RFP Title: General Contractor Services for Elmwood Community Center CPF Improvements

Addendum #: 2

TO ALL BIDDERS OF RECORD: ELMWOOD COMMUNITY CENTER CPF IMPROVEMENTS - GC

REQUEST FOR INFORMATION – (RFI)

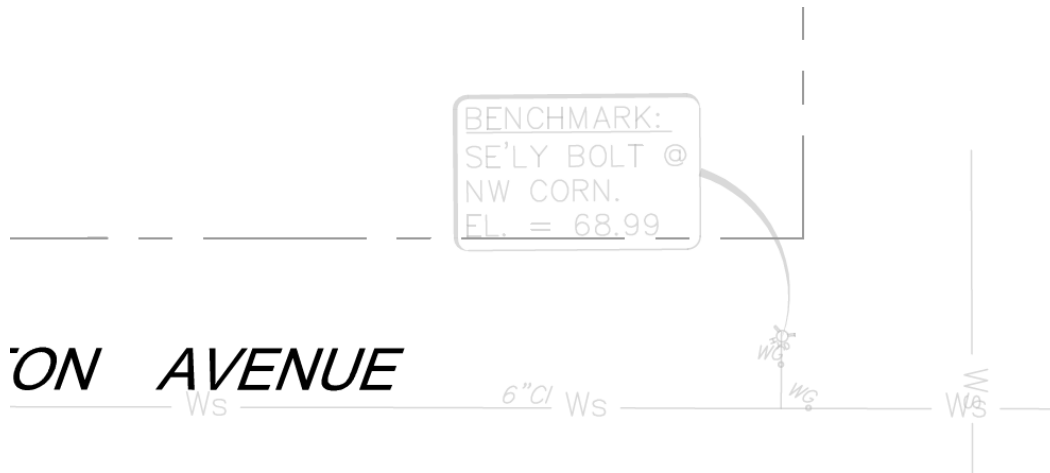
2. **RFI:** On Sheet D100, Note D13 calls for the removal of the existing sewer line but not shown on the civil drawings C-2. Are we supposed to cut and cap at the curb line? No detail is provided. Please provide a detail.

Response: Cut and cap existing sewer line within the area of construction which is approximately 10' from the exterior face of the building.

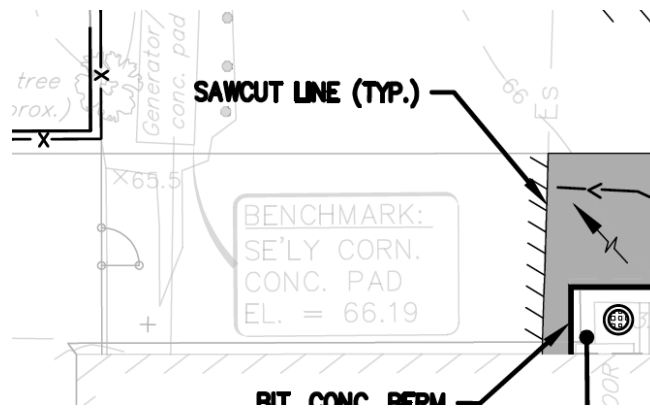
4. **RFI:** On Sheet C2, elevations are called out on the plans, but no benchmark is shown. Please provide an existing elevation plan so we can determine the depth of the subsurface infiltration work.

Response: Drawing snippets shown below for convenience. Sheet C-2 reflects benchmarks as follows:

SE'ly BOLT of FH Lexington at Niagara
 El 68.99

SE'ly CORN CONC PAD at Generator
 EL 66.19

C-2

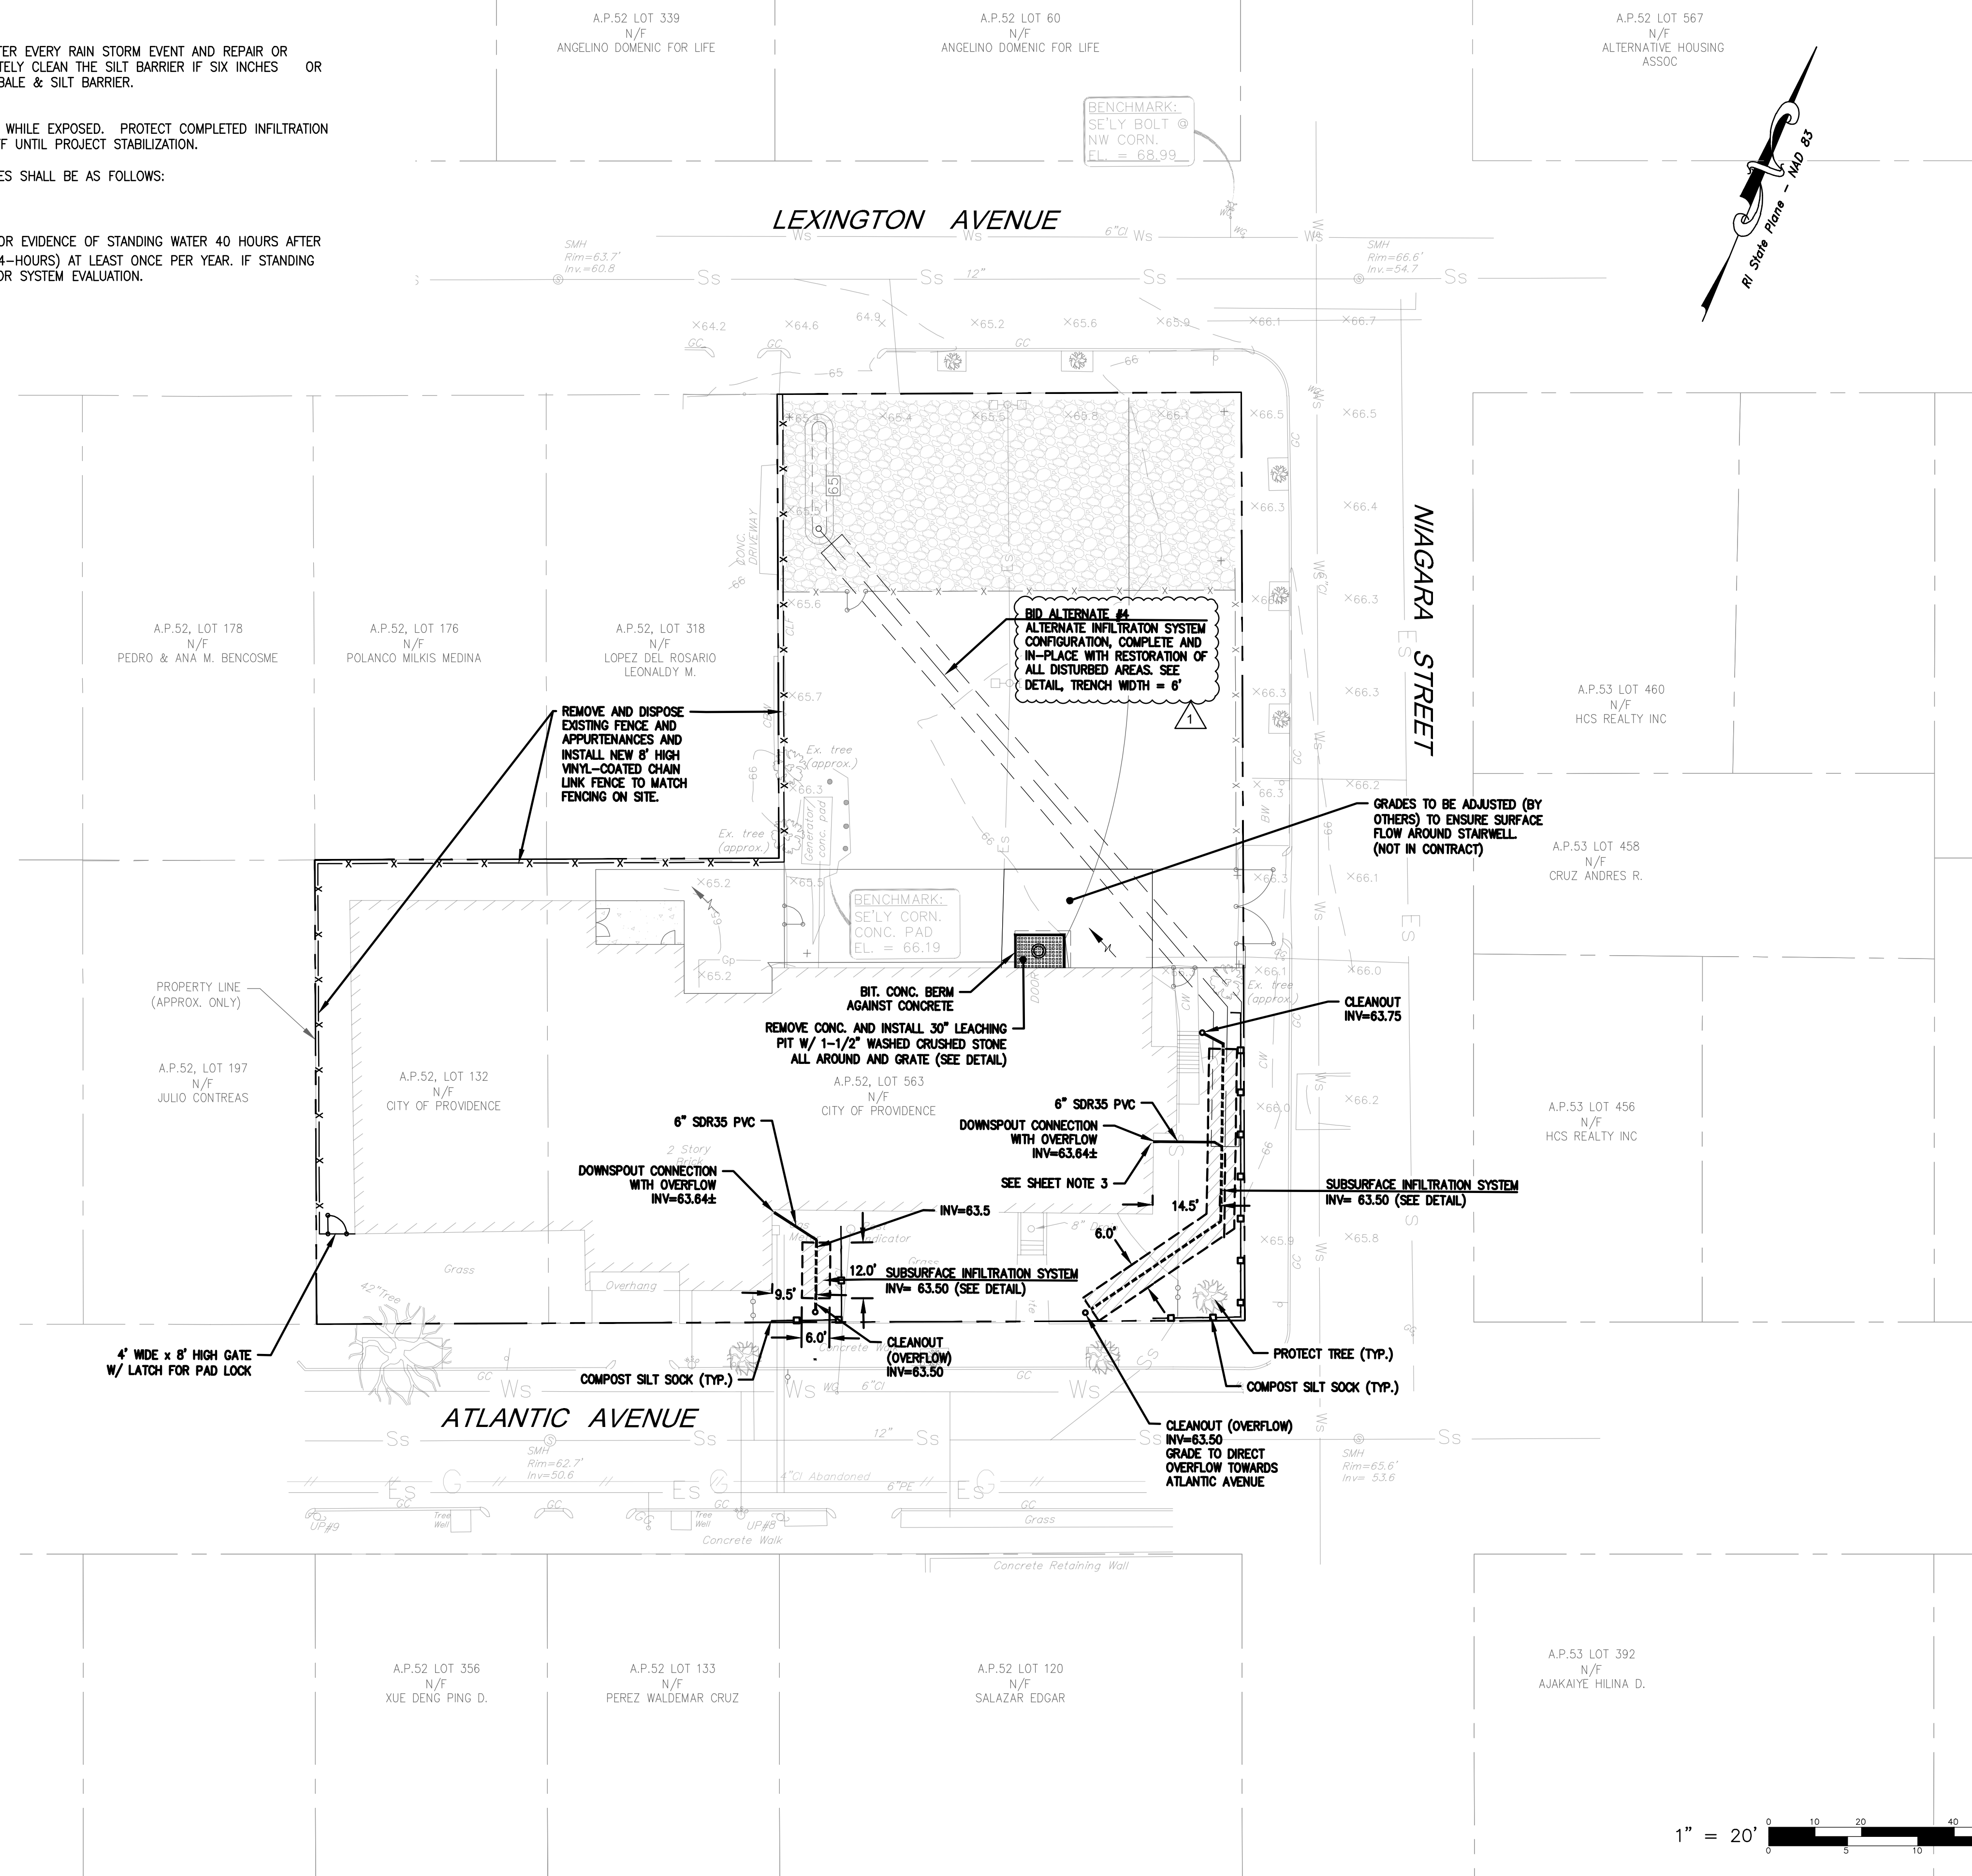
1. **RFI:** Sheet C-2 - It shows a bid alternate for alternate infiltration system. It is not clear where the alternate begins and where it ends. Please show the grades for this alternate. It does not seem like there is enough pitch. Also, no alternate is shown on the bid documents for this line item.

10. **RFI:** On Sheet C-2, on the right-hand stairwell it says to connection downspout. It says to see Sheet Note 3. There is no Note 3 on the plans. Please provide.

Response: Bid Alternate for infiltration system is Add Alternate 4.

Response: Sheet Notes in upper right corner of sheet C-2. See note number 3.

LEACHING PIT
 N.T.S.

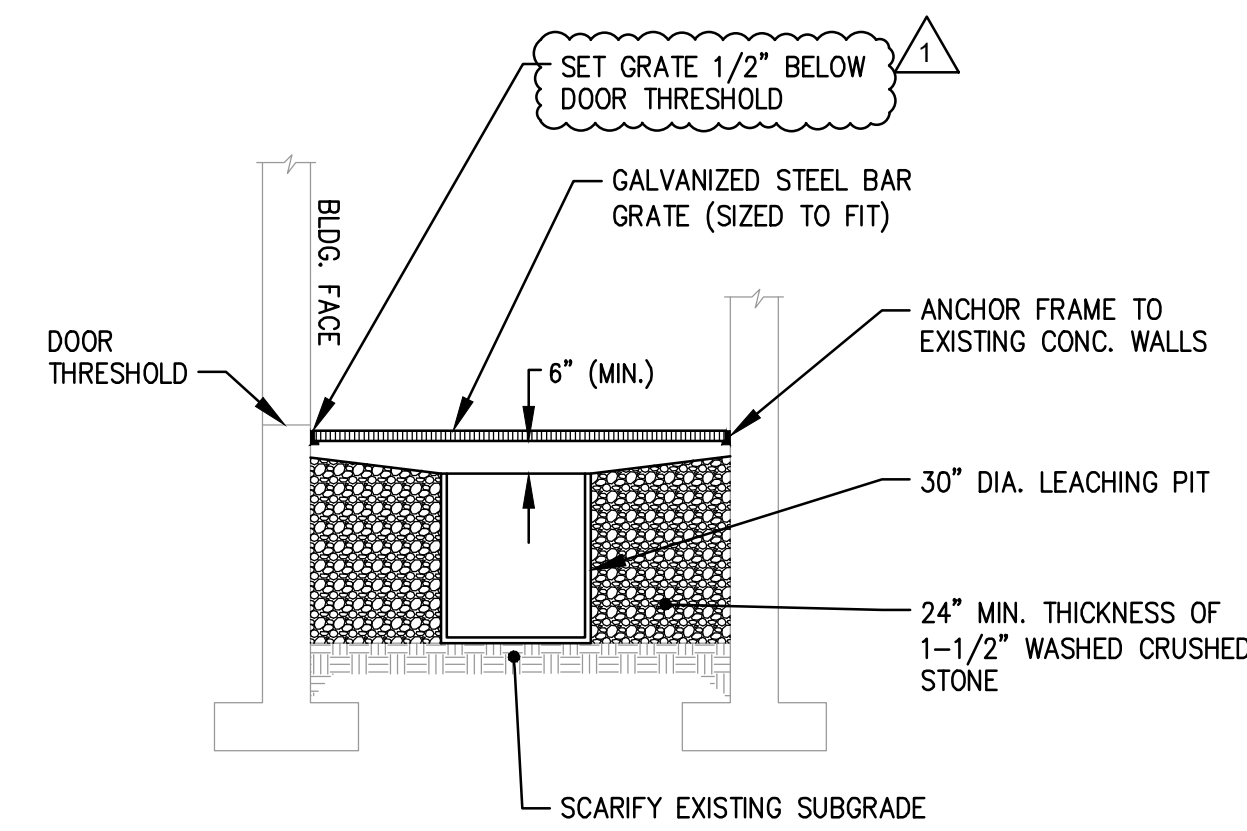
8. **RFI:** On Sheet C-2, it calls for us to remove concrete at the bottom of the existing stairwell to the basement in the back of the building. The detail on C-3, calls for this leaching pit to be set 1" below door threshold. The current concrete is flush with the door. Please confirm that this won't be a trip hazard if we drop in one inch. If it is lowered 1 inch, then the existing stairs would not meet code due to changing riser height. They would need to be removed and re-poured.

Response: New grate to be set ½" below door threshold and as directed at Leaching Pit Detail on sheet C-3 Revision 1, dated 05-09.2025.

1 FIRST FLOOR PLAN
 A100 SCALE: 1/8" = 1'-0"

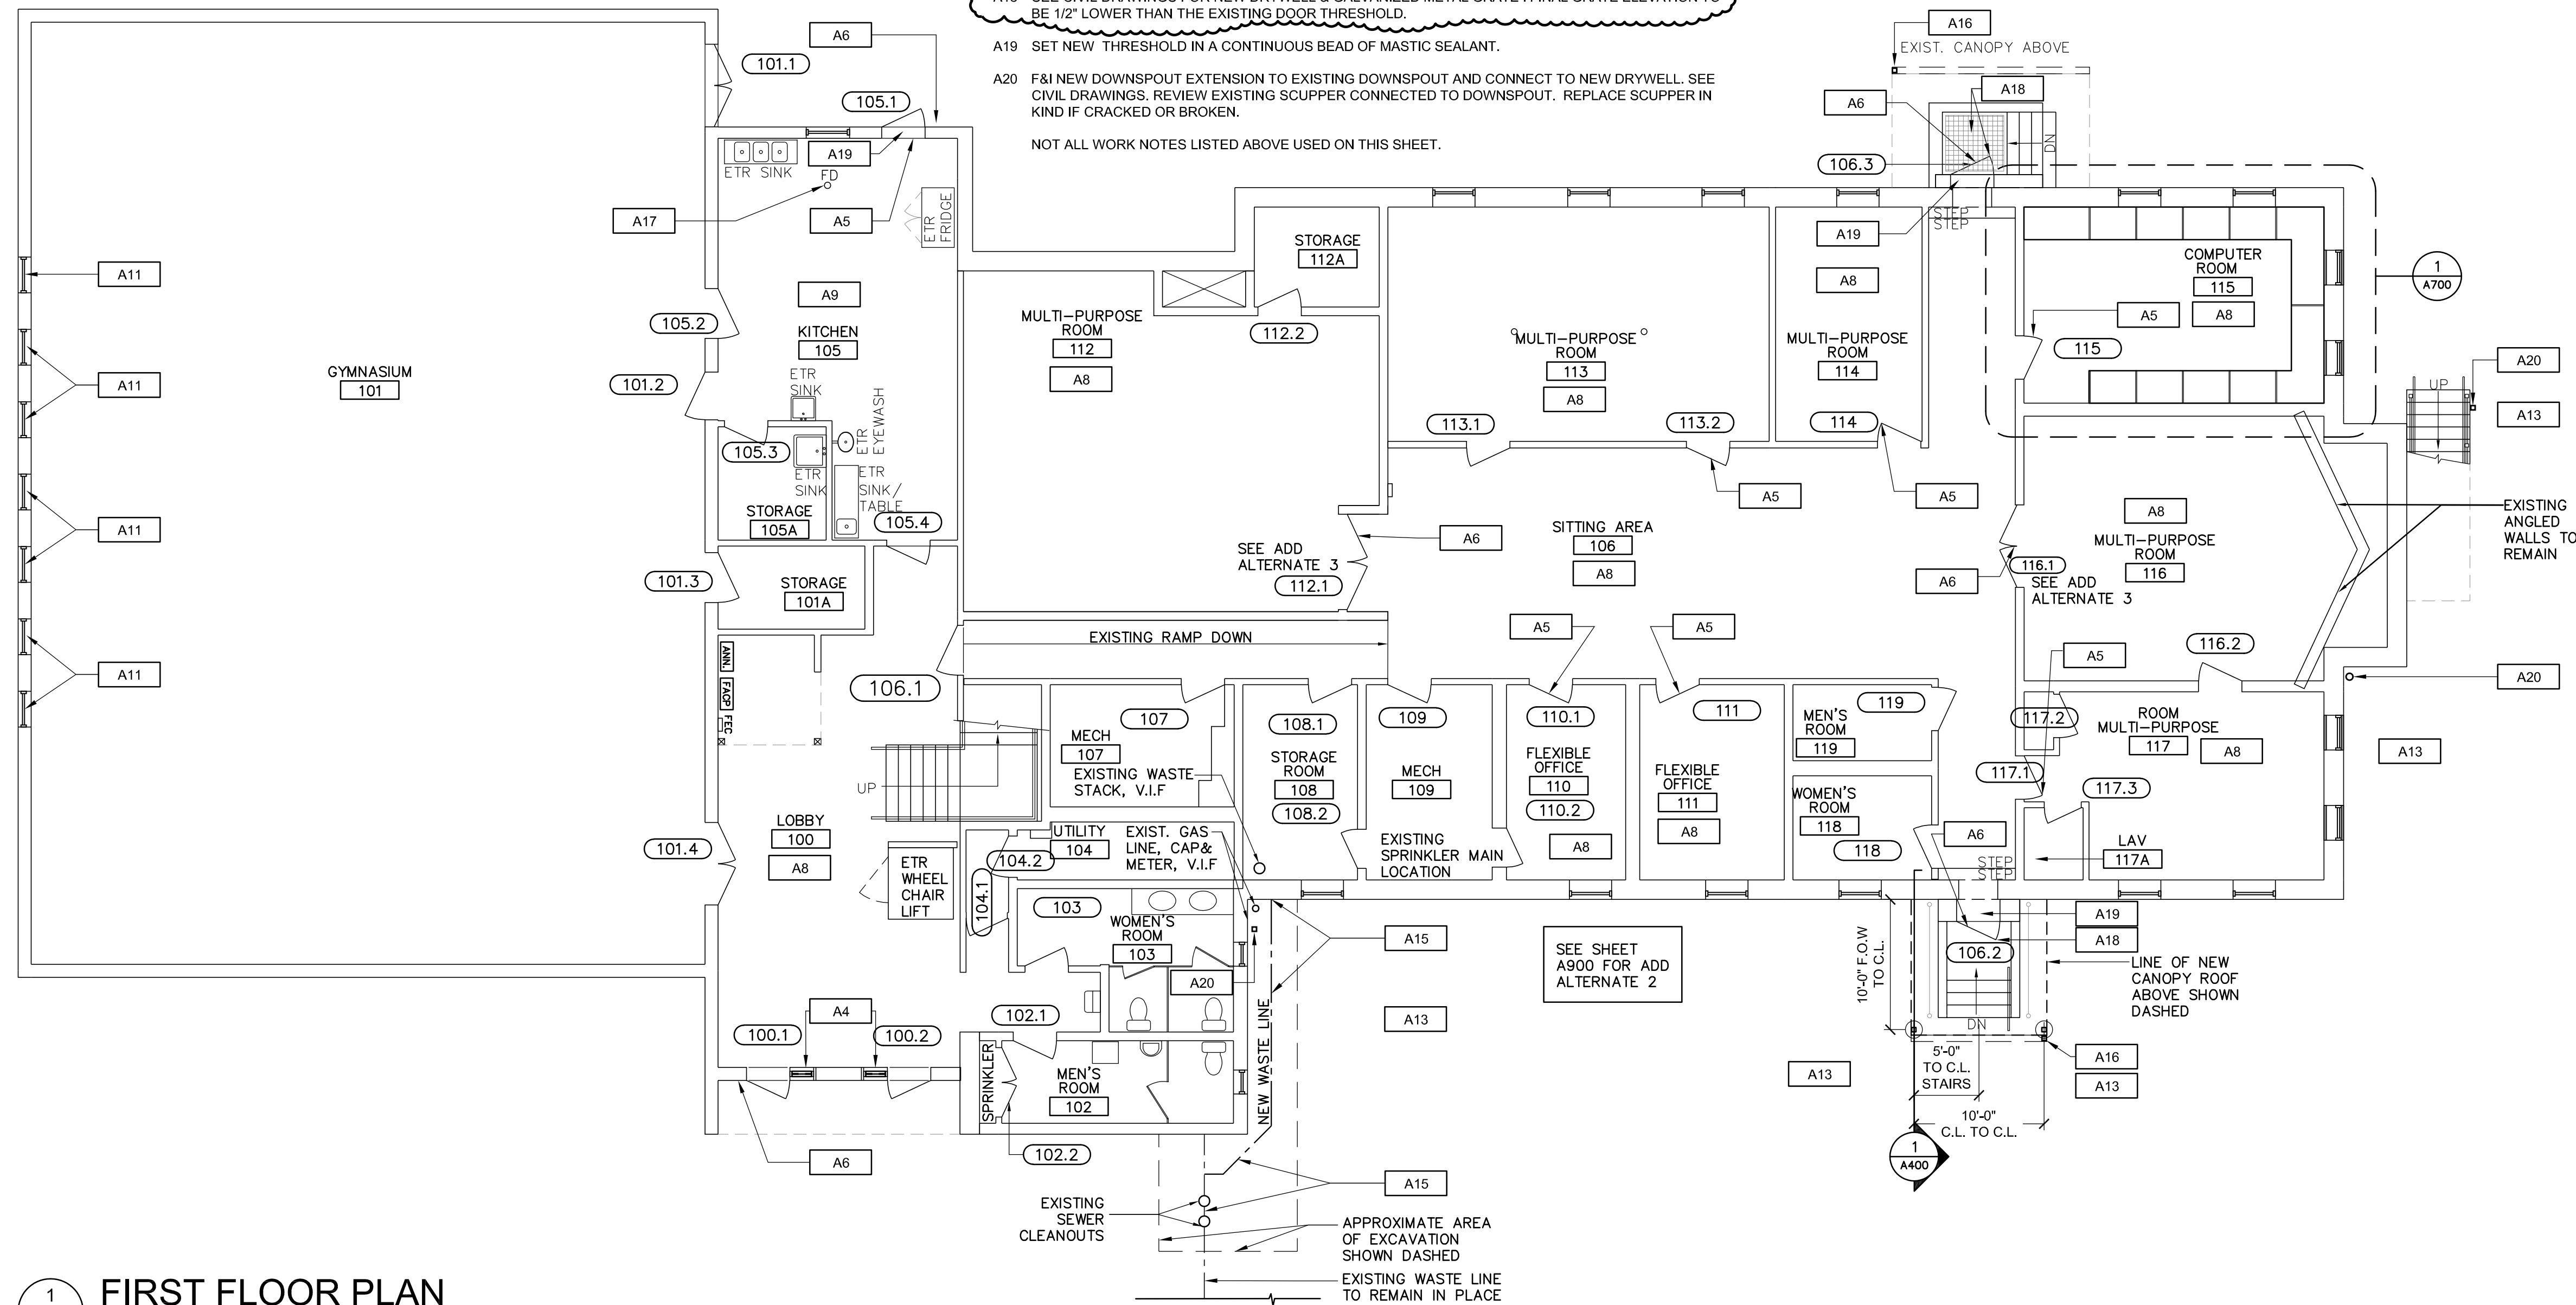
3. **RFI:** On Sheet A100, Note A15 calls for a new sewer line and to see civil drawings. No details or anything is shown on C-2 for this work. Please provide a detail.

- 5. **RFI:** On A100, a new canopy shown in front of the building. It calls out in Note A16 a gutter detail and see civil drawings. The entire canopy, gutter and grading is not shown on the civil plans. Please update C-2 to show this work and the necessary grading around. Please confirm that the existing fence is also supposed to be removed that surrounds the stairs.

9. **RFI:** On A16, a new gutter and downspout is shown on the existing canopy in the back of the building. Connection to direct water away from the building. See civil drawings. Nothing is shown on the civil drawings. This area just got re-asphalted so it's unclear the exact scope of work and the coordination.

19. **RFI:** Note A17 on drawing A100 states to review existing floor drain, cleanout, and pipe connection. Please clarify the scope bidders shall include in pricing.

Response: Delete the text "see civil drawings" from Note A15 on sheet A100.

Response: At note A16, delete the text “see civil drawings”. The existing chain link fence on either side of the stairs will remain. Provide splash block similar as shown on the Downspout Connection with Overflow detail on sheet C-3 and directed on Civil drawings. See 1/A400.

Response: Delete the text "see civil drawings" from Note A16 on sheet A100. See 1/A400 for rear canopy. The existing asphalt is to remain.

Response: Remove drain cover. Clean drain cover and area directly below drain cover. Snake existing drainpipe to ensure there is no blockage.
